12 June 2024

SB Civil
C/-
Laila Alkamil
Senior Planner
Williamson Water and Land Advisory

RESPONSE TO ADDITIONAL INFORMATION REQUEST – 1618 ARARIMU ROAD, PAPAURA

Rev	Revisions	By	Date

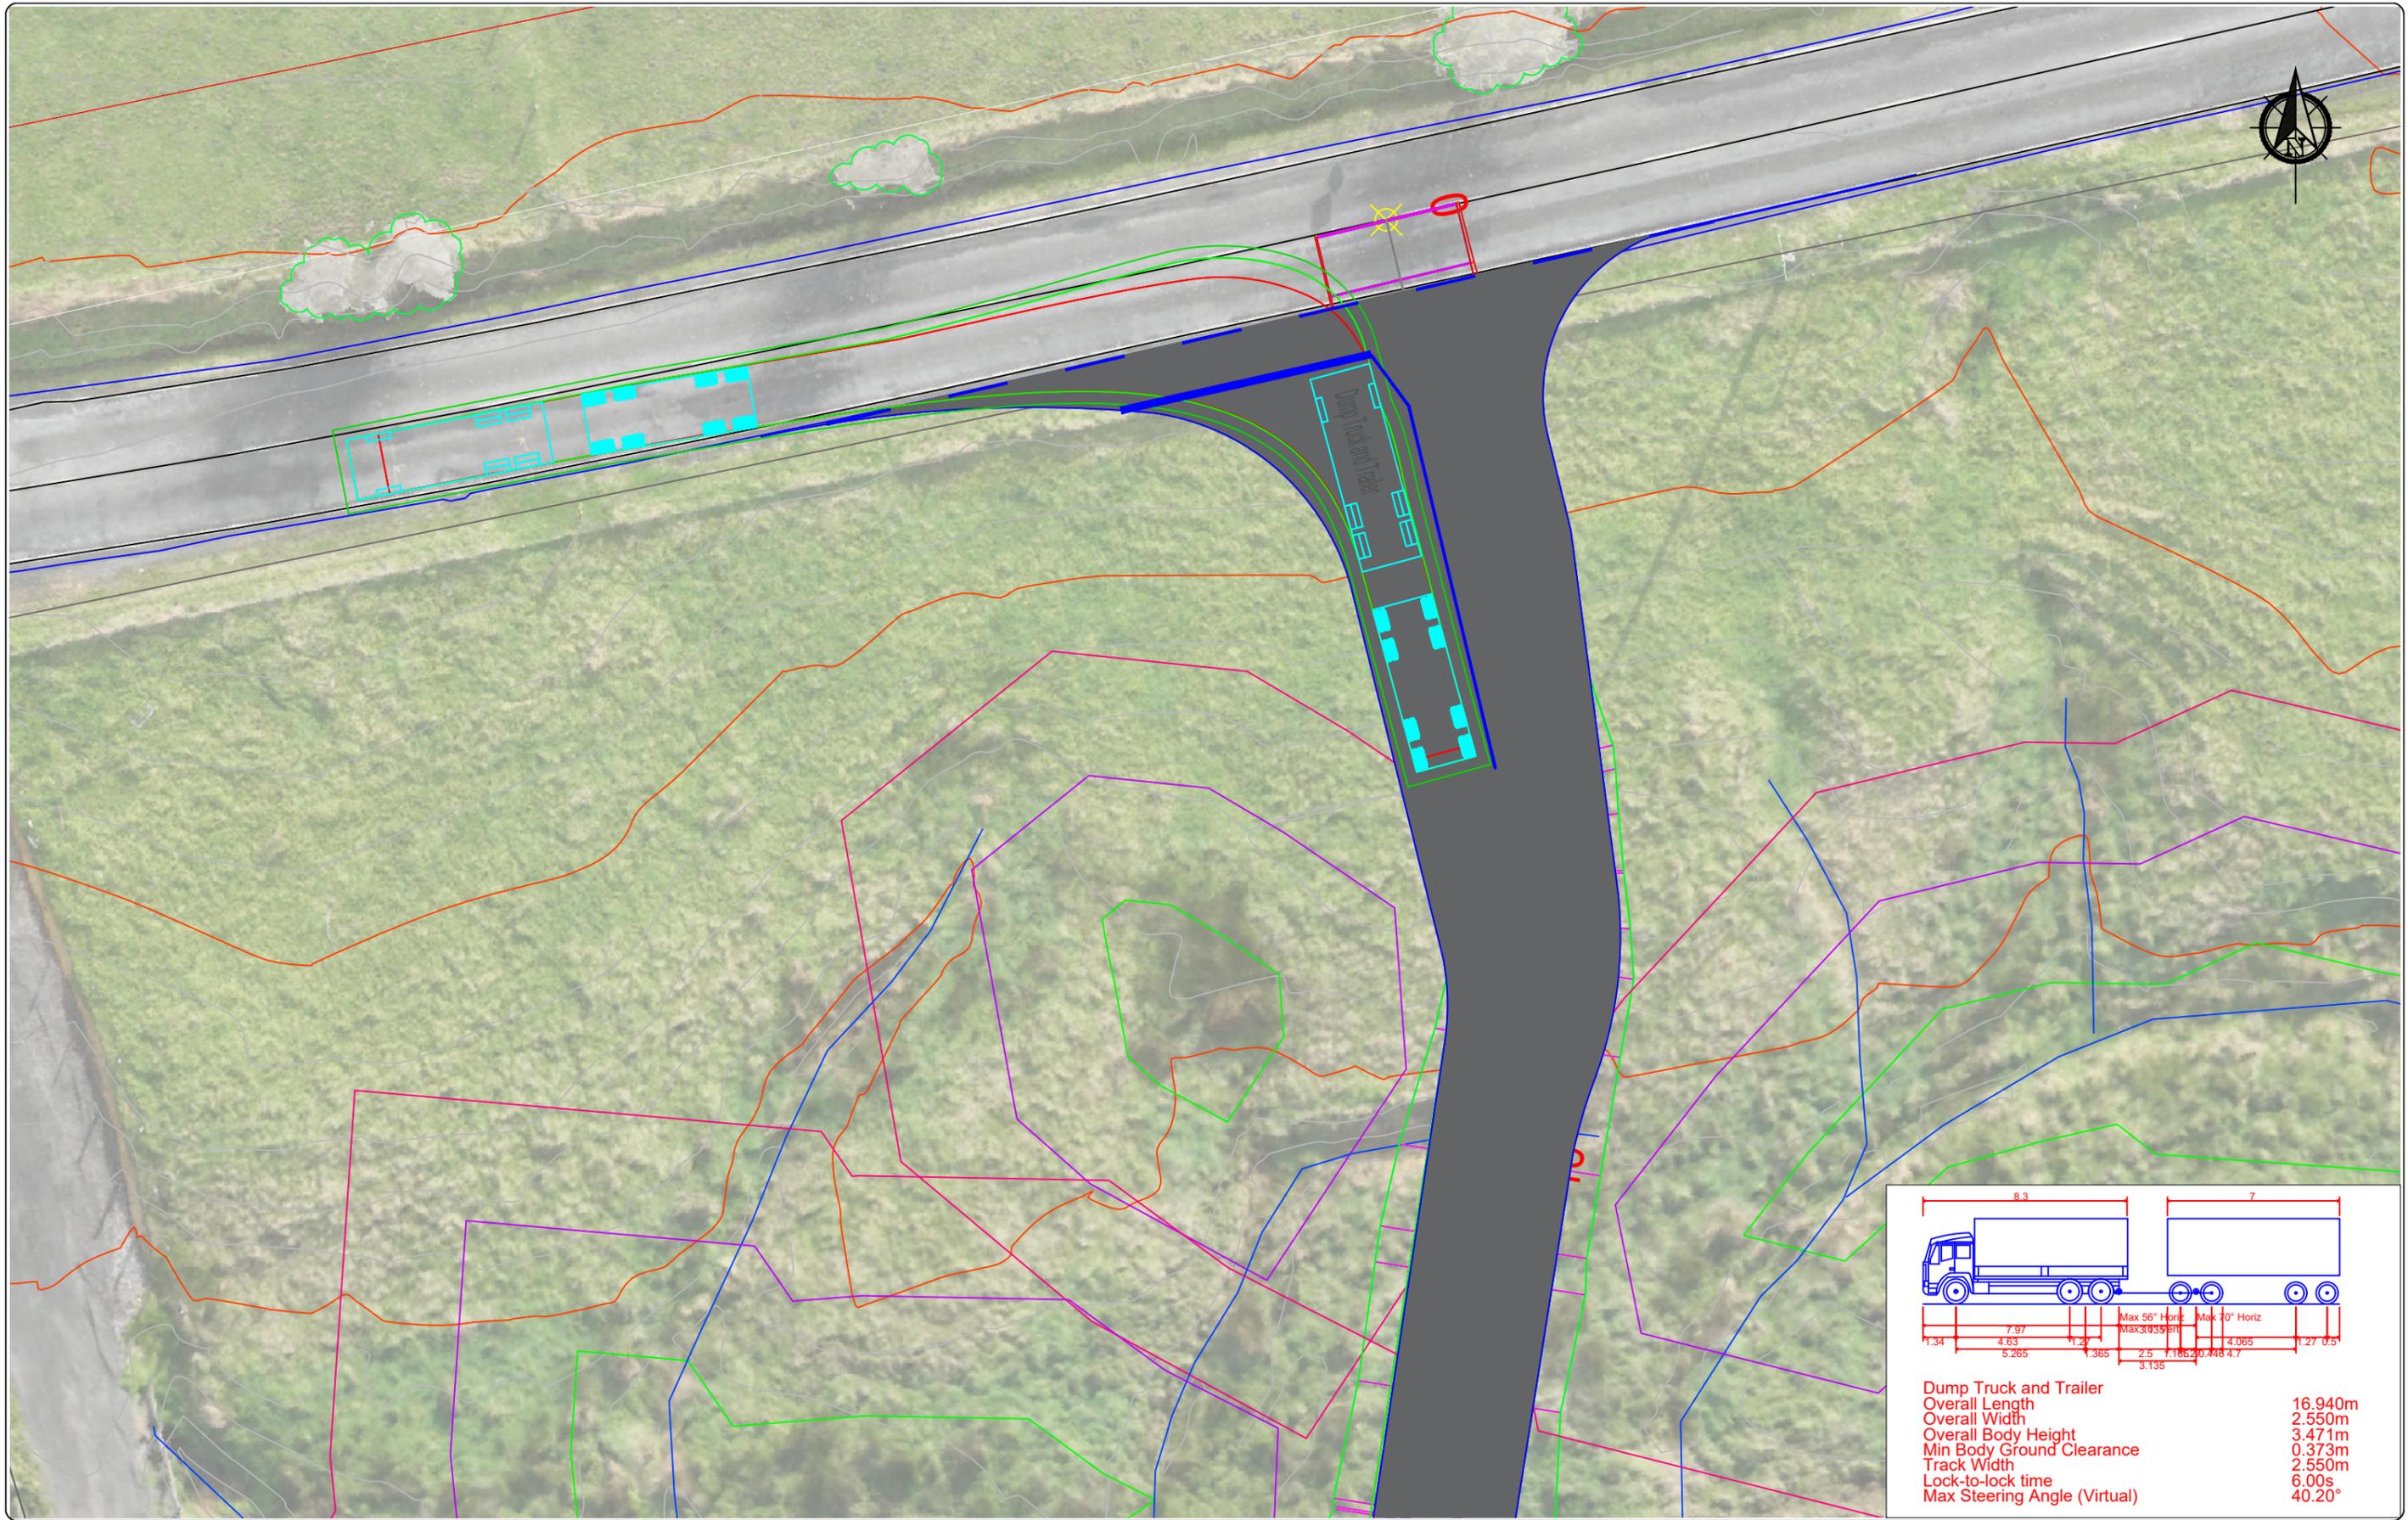
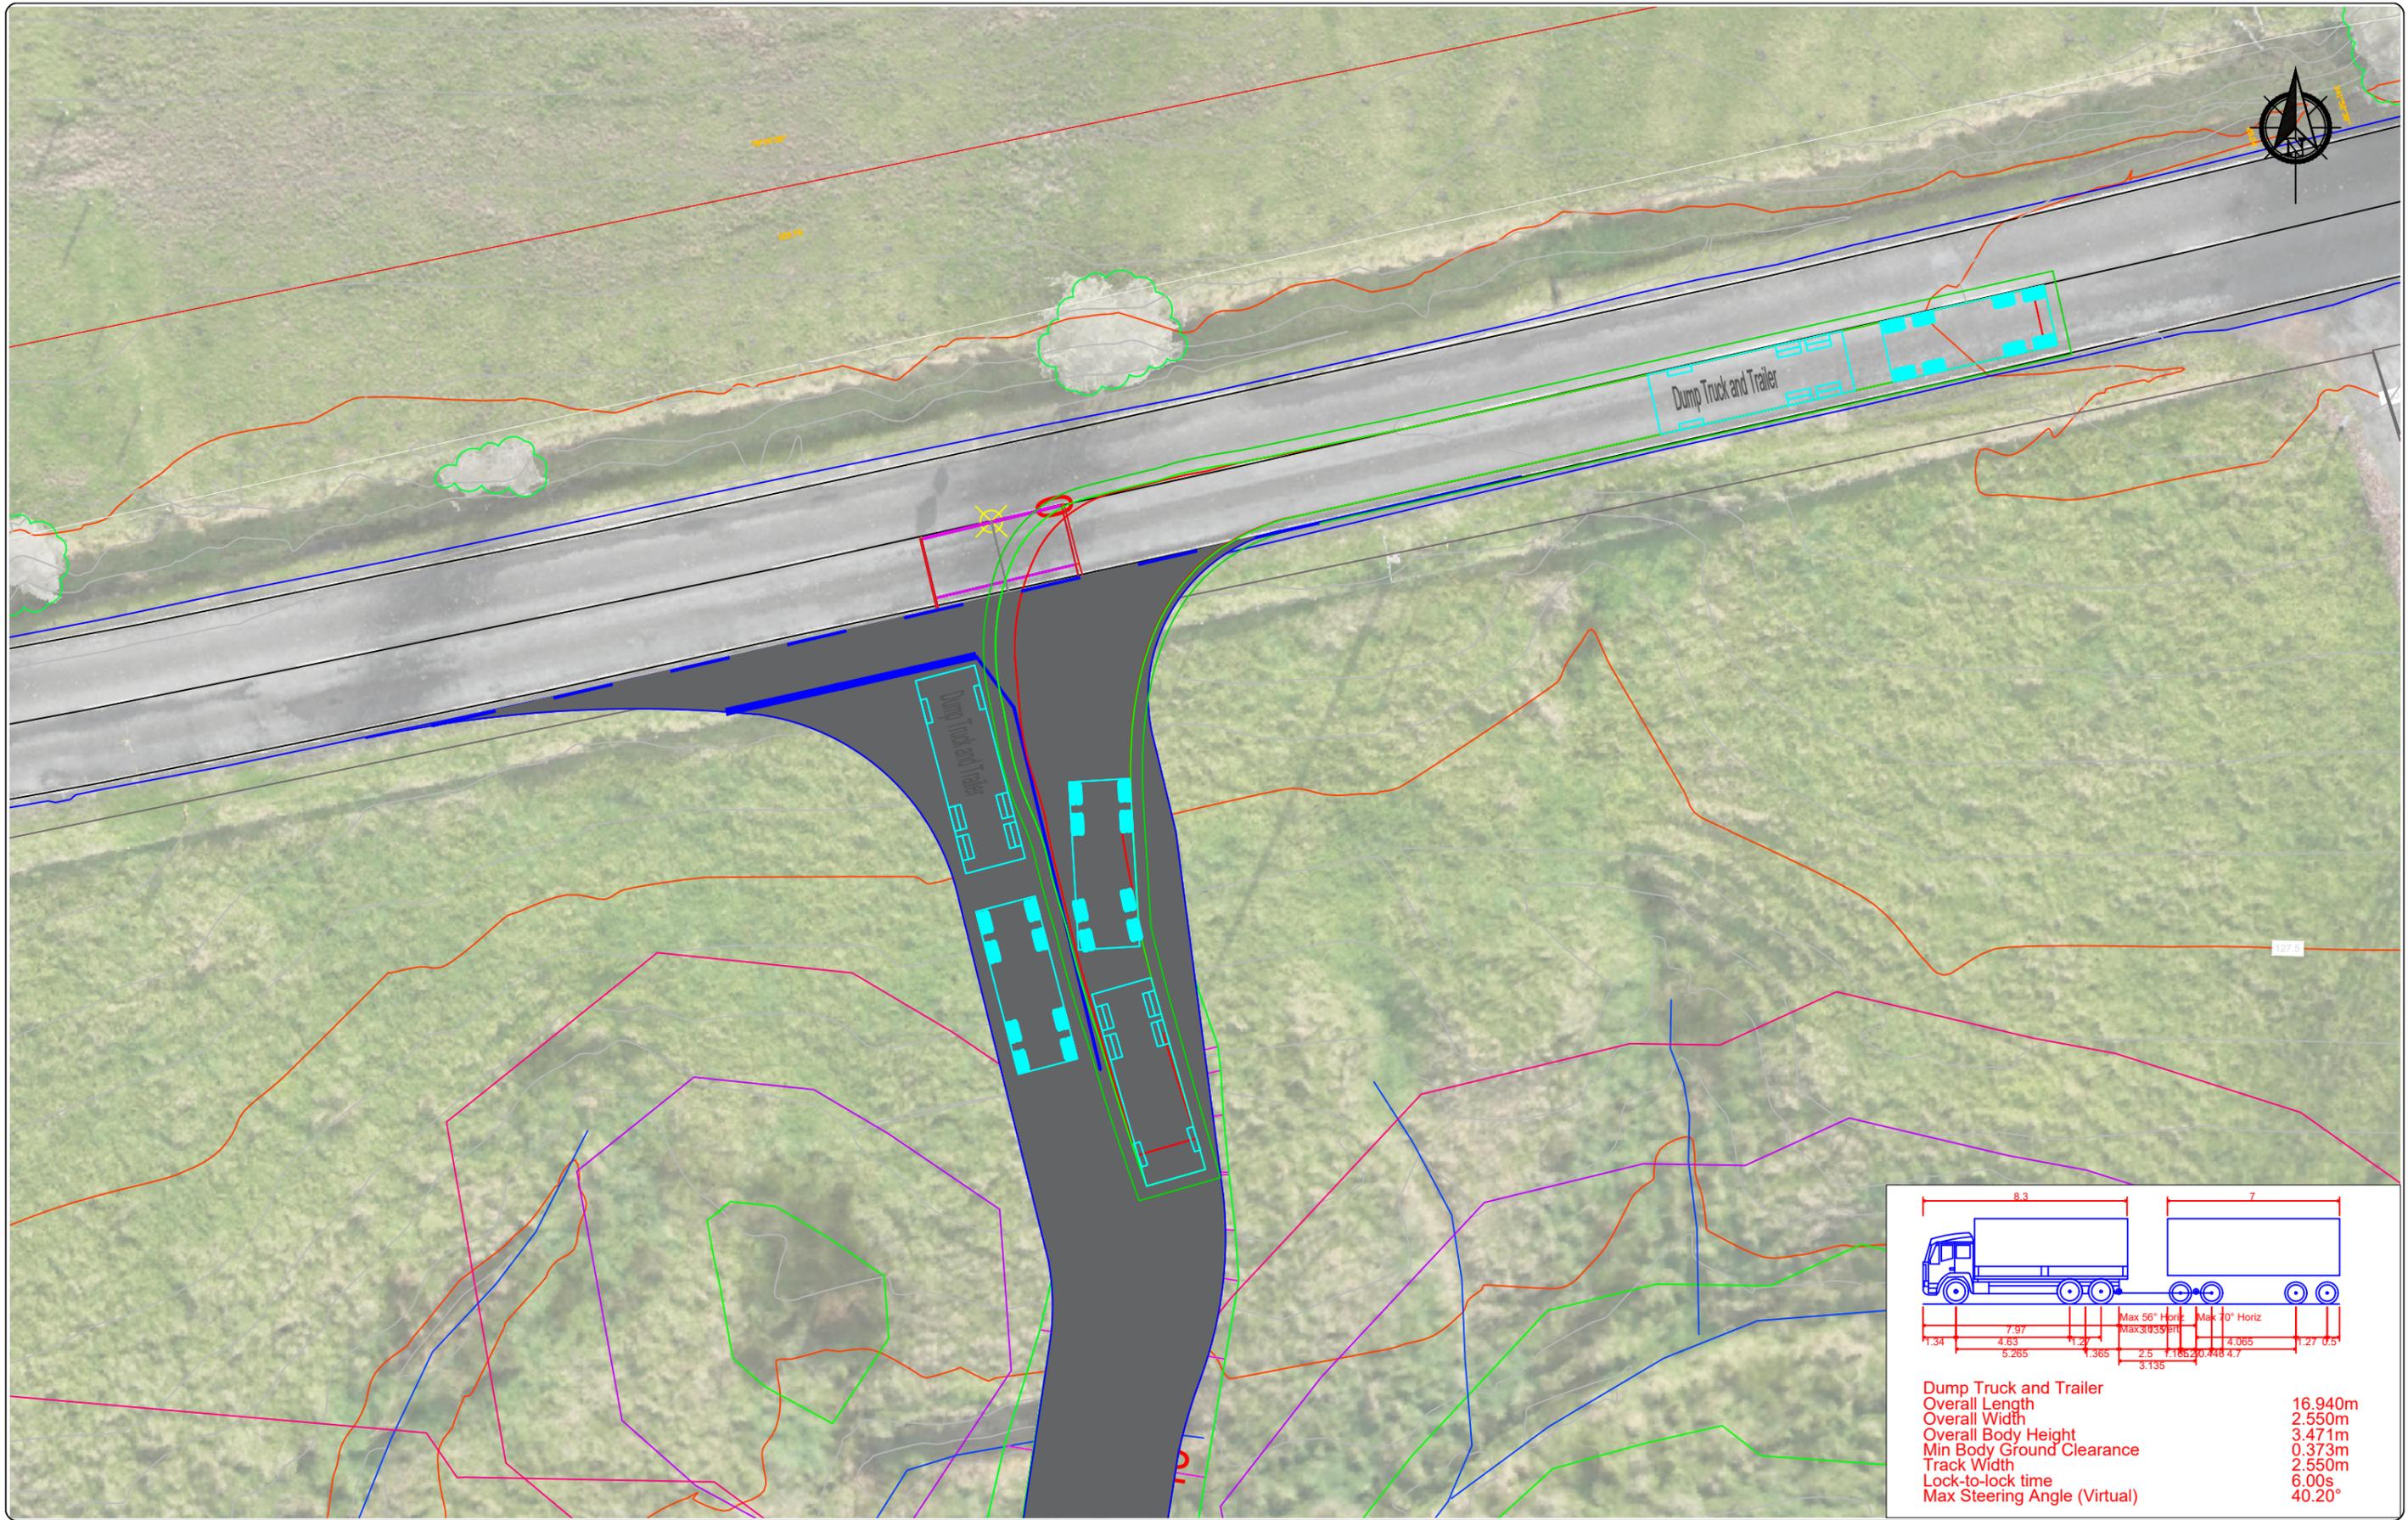
Please provide tracking of the 17m Dump Truck and Trailer around the bends of the internal driveway to ensure truck stays within the internal driveway.

Vehicle tracking curves for the internal access have been prepared and are included in the **Attachment**.
